Adequacy Review #3 / TR-05 / Lyons Quarry / M-1977-141

Attached is Technical Revision 5, Version 3 for your review. As in previous submittals, Attachment E-1, the Kleinfelder Stability Report, is not included due to its file size. The crosswalk spreadsheet will help identify the changes that were made to the document. We hope this revision satisfies the Division's concerns but please review and let us know if you have any follow up questions.

I'm attaching our adequacy review #3 letter for TR-05.

TYPICAL ROCK REINFORCEMENT (NUMBER 10) DETAIL

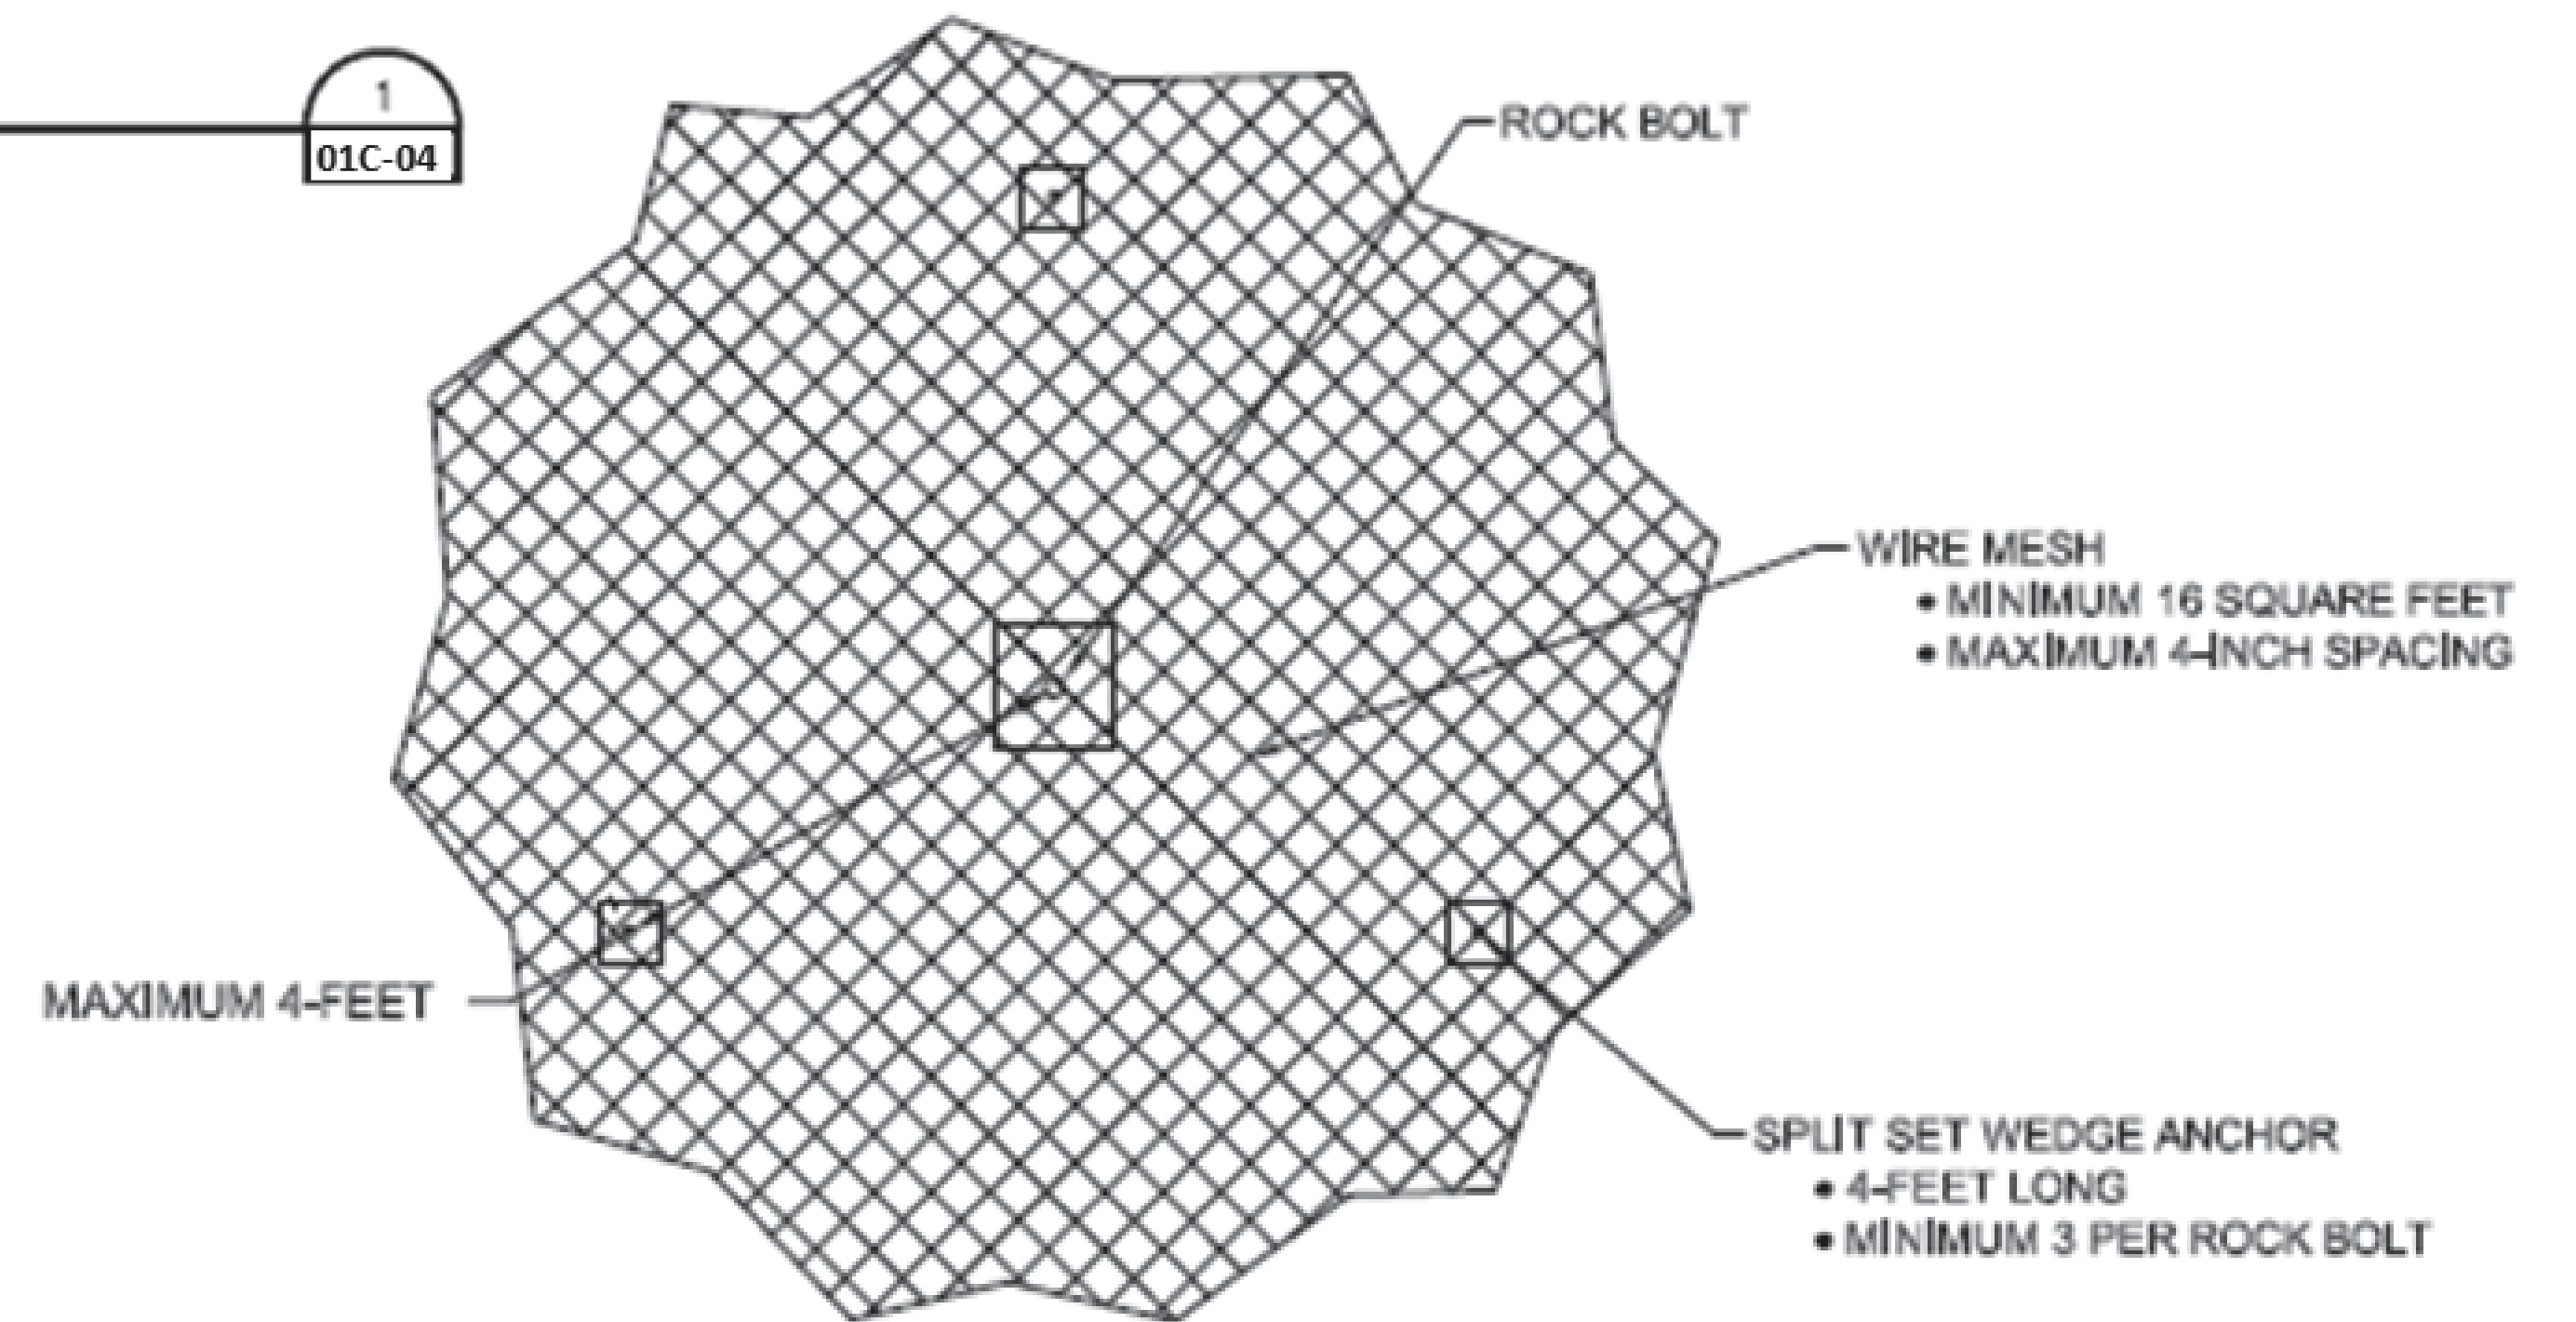
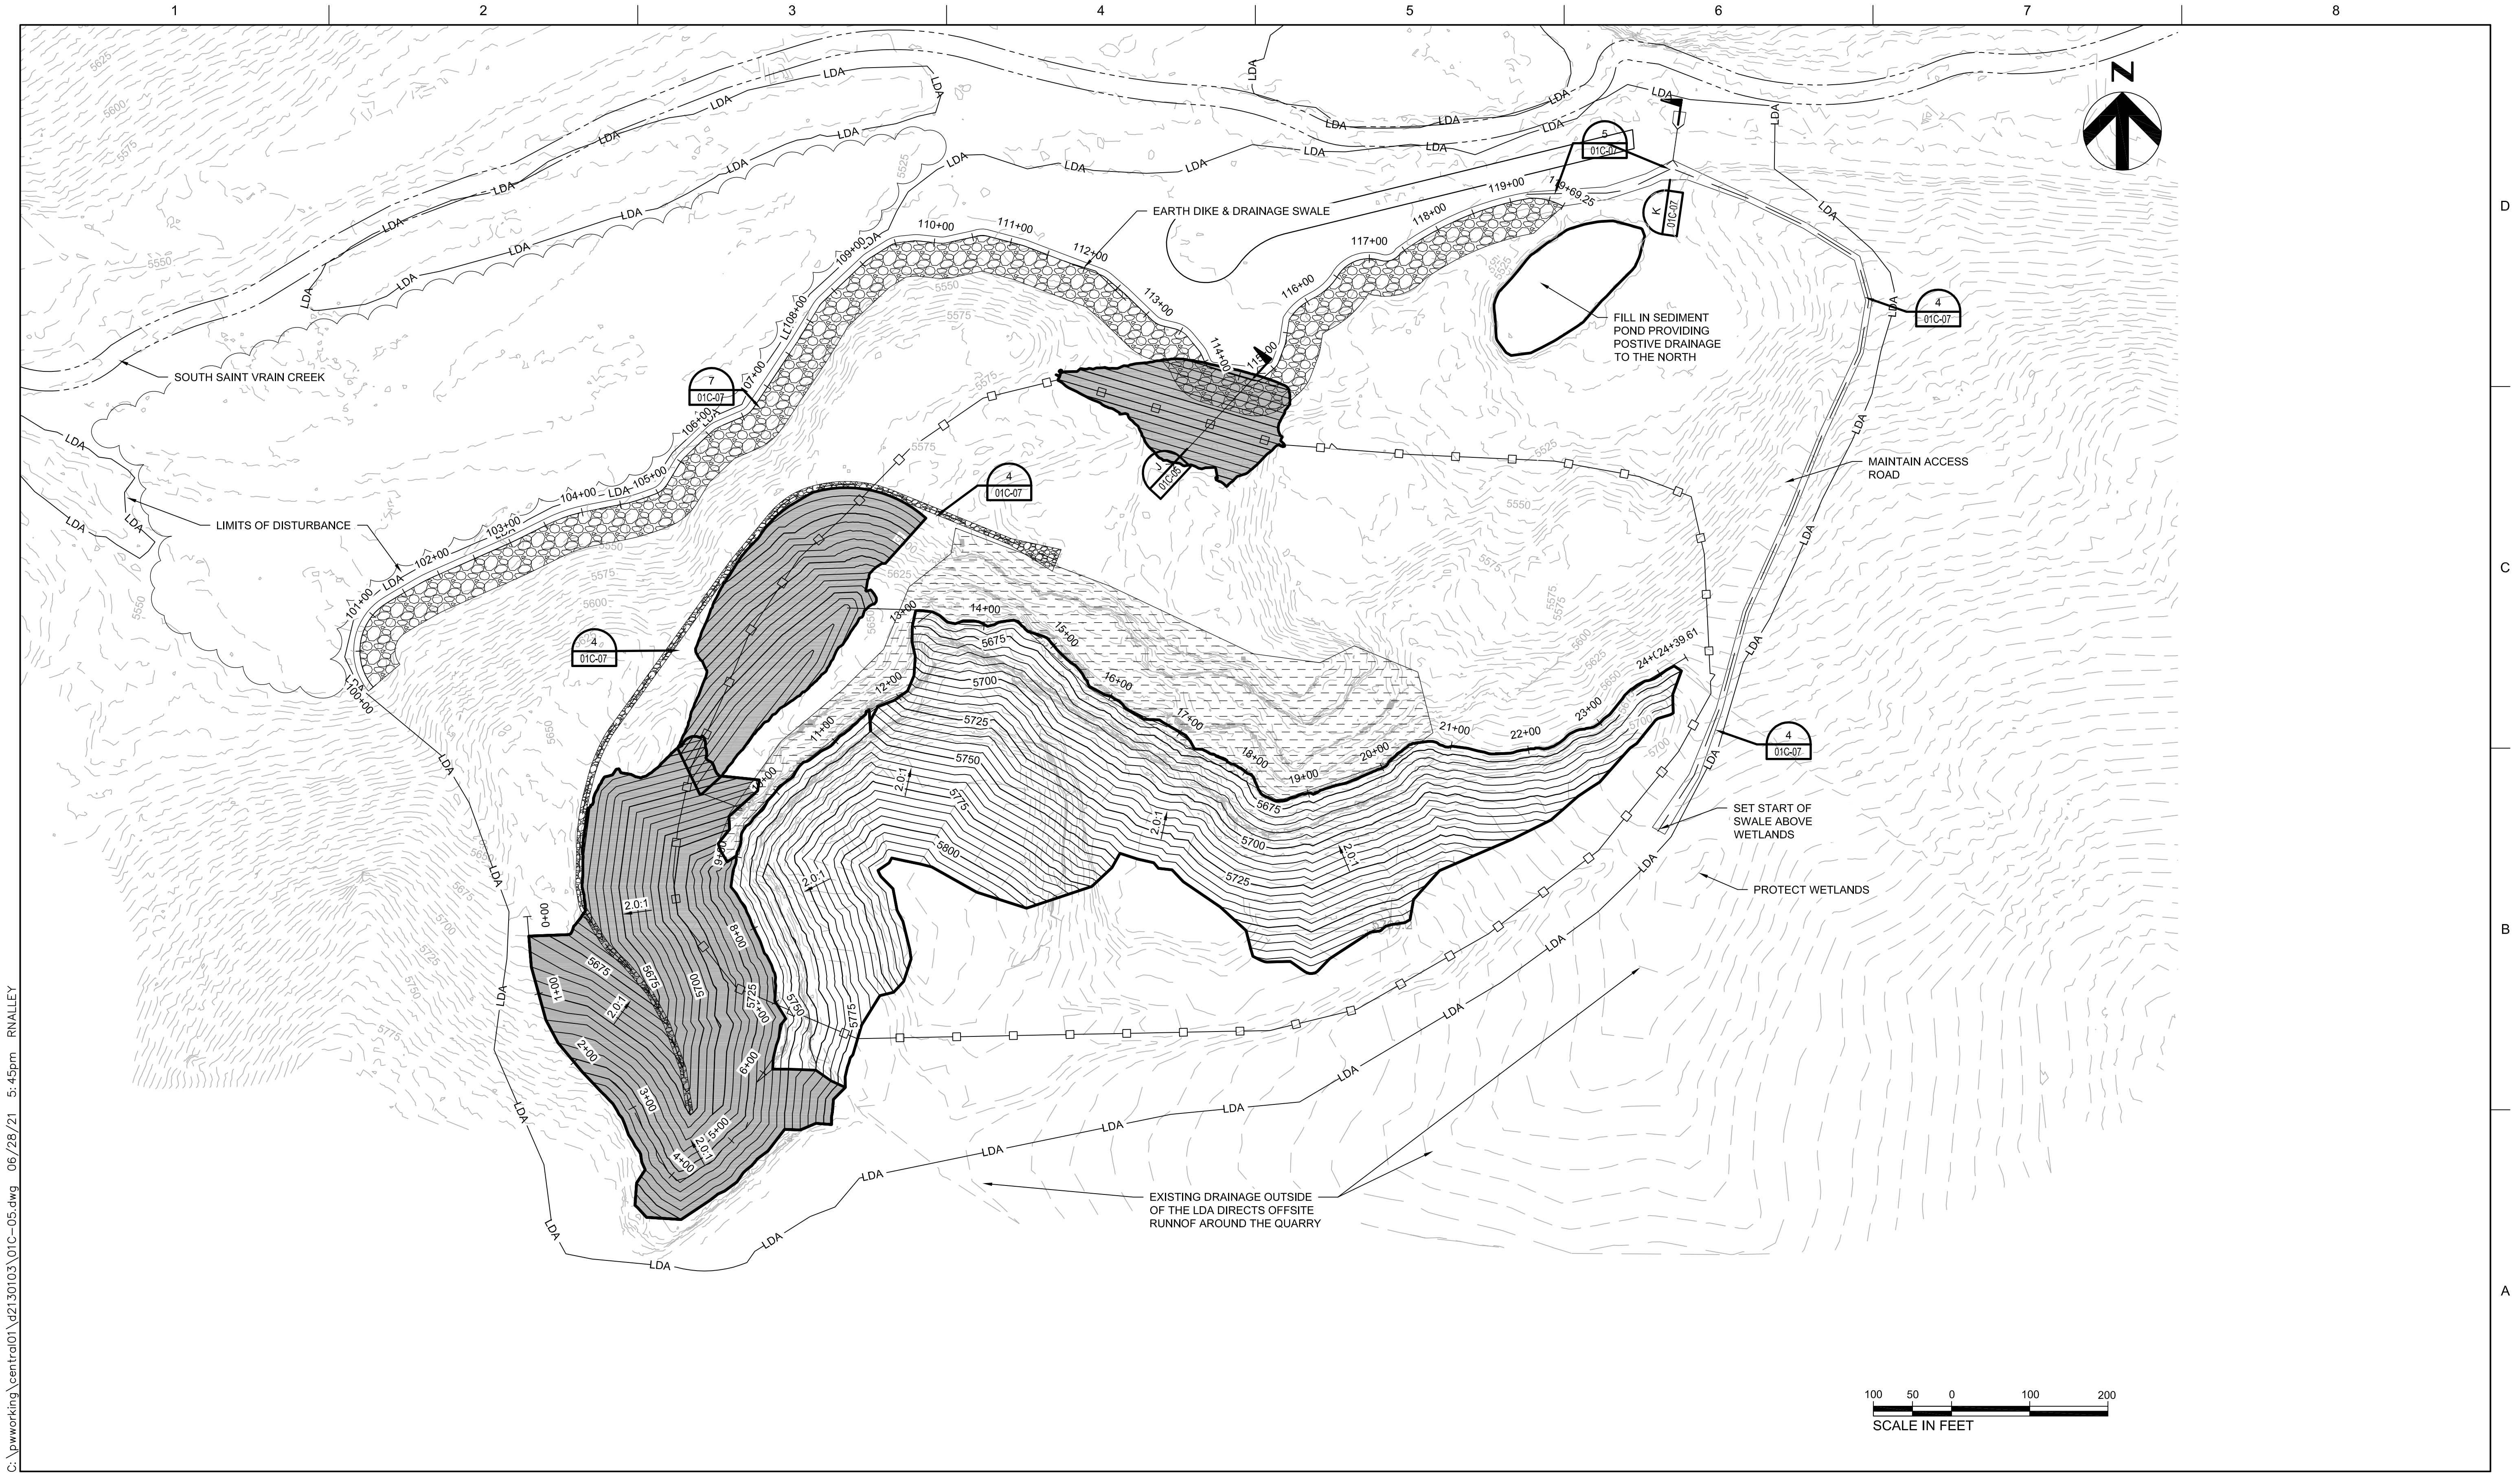
ix.	Anchor bolt detail: The DRMS would expect a rock anchor detail is not premature at this time given the stereonet and rock strengths in the Kleinfelder report. An additional detail similar to the FHWA detail below should be included as well	Add call-out and detail for rock reinforcement on new page 01C-04.	New Sheet 01C-05
2	Site Grading Plans: The response was not adequate. Additional clarification is required with respect to maintenance. Given wire mesh is inferred to be substituted for shotcrete, the DRMS and the landowner should be made aware of the rock anchor system inspection points and potential for maintenance of the same. Please address the following:
